# ARTEGON REPLAT

## SUMMARY

<p><b>Owner</b> FB Orlando Acquisition CO. LLC Paragon Outlet Partnen LLC</p> <p><b>Applicant</b> Craig Pugh, Survey Man- ager VHB</p> <p><b>Project Planner</b> TeNeika Neasman</p> <p><b>Updated:</b> July 7, 2015</p>	<p><b>Property Location:</b> 5150 International Dr. is south of W. Oak Branch Rd., west of the Florida Turnpike, and east of International Dr. (±100.66 acres, District 6)</p> <p><b>Applicant's Request:</b> Applicant is requesting a replat of commercial land (Lot 4 and 5) into three lots with access tracts for development.</p>	<p><b>Staff's Recommendation:</b> Approval of the request, subject to the conditions in this report.</p>
--	---	--

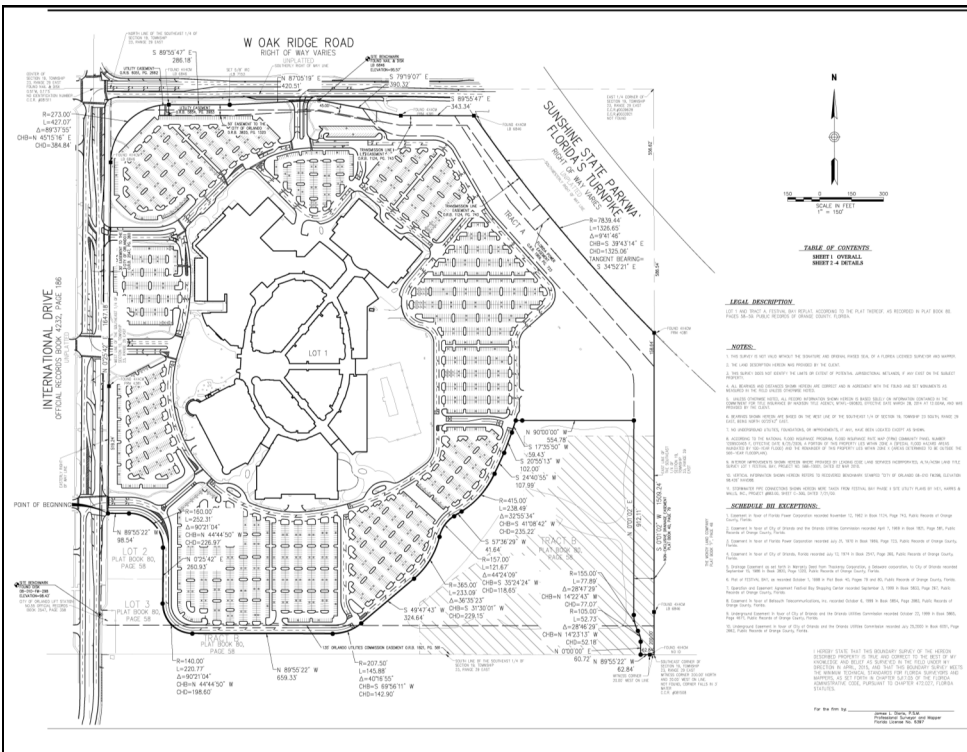
1. The plat you have submitted for the first time called Artegon has not passed the review process for the following reasons:
  - Sheet: Boundary and Topographic Survey isn't signed and sealed.
